Technical Service Bulletin

Subject: CONVERTIBLE TOP INNER CLOTH FALLING DOWN CAUSING POOR APPEARANCE AND OBSTRUCTING VIEW OF BACK WINDOW	Bulletin No.: 09-005/17
	Last Issued: 02/17/2017

This bulletin supersedes the previously issued bulletin(s) listed below. The changes are noted below in Red.

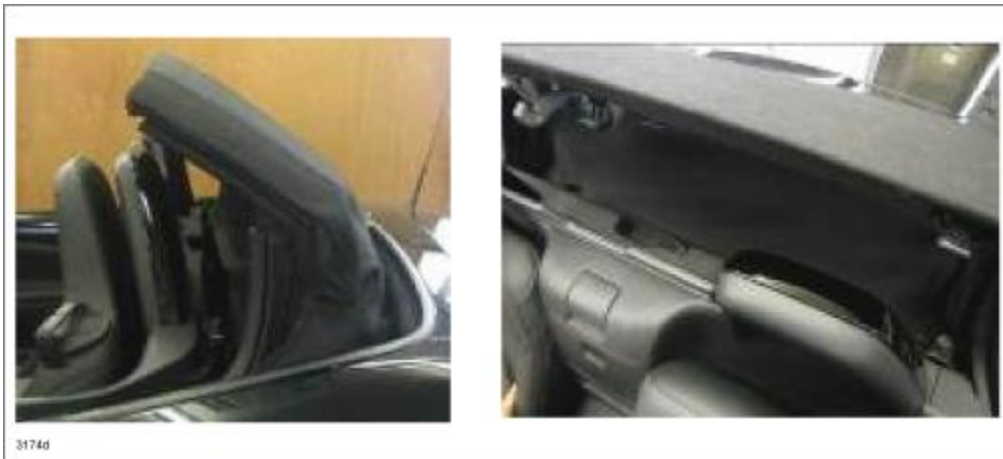
Order the new clips and cut off the ribs. Add adhesive to the inside of the clips and install them to the both sides of the J-hook according to step 3 in the Repair Procedure.

NOTE: The clip has a rib. Cut the rib before installation to the J-hook. Since the rib is an obstacle when

installing itself to the inner cloth, cut the rib off, and add the adhesive to inside of the clip to stabilize it and prevent the J-hook from sliding.

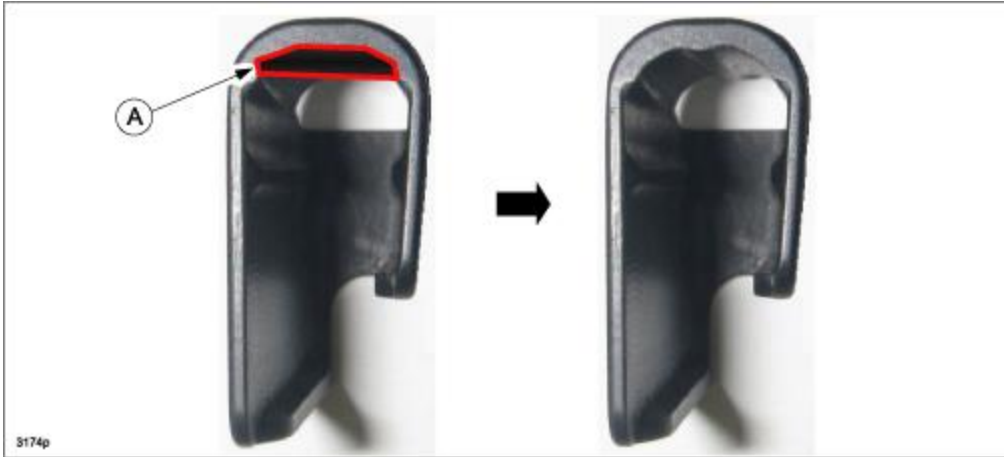
a. Cut off the shaded area (A) of the clips (for both left and right sides).

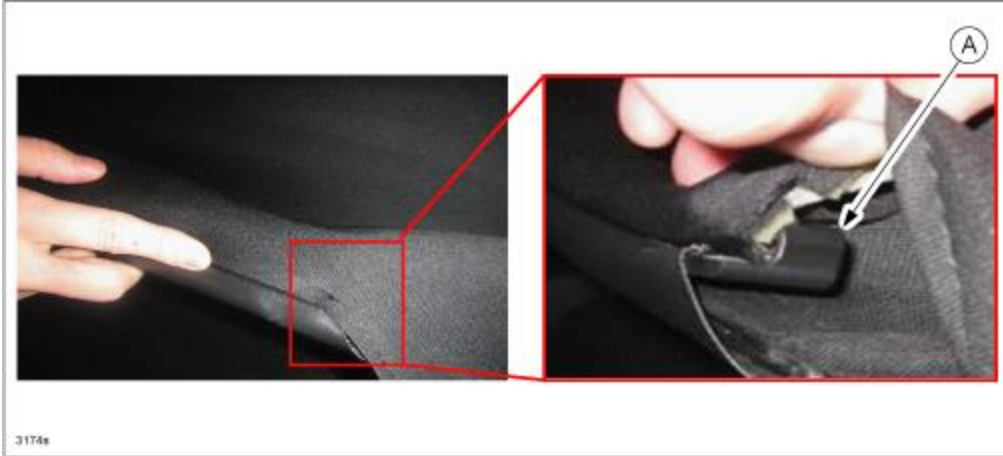
c. Install the clips (A) to both edges of the J-hook.
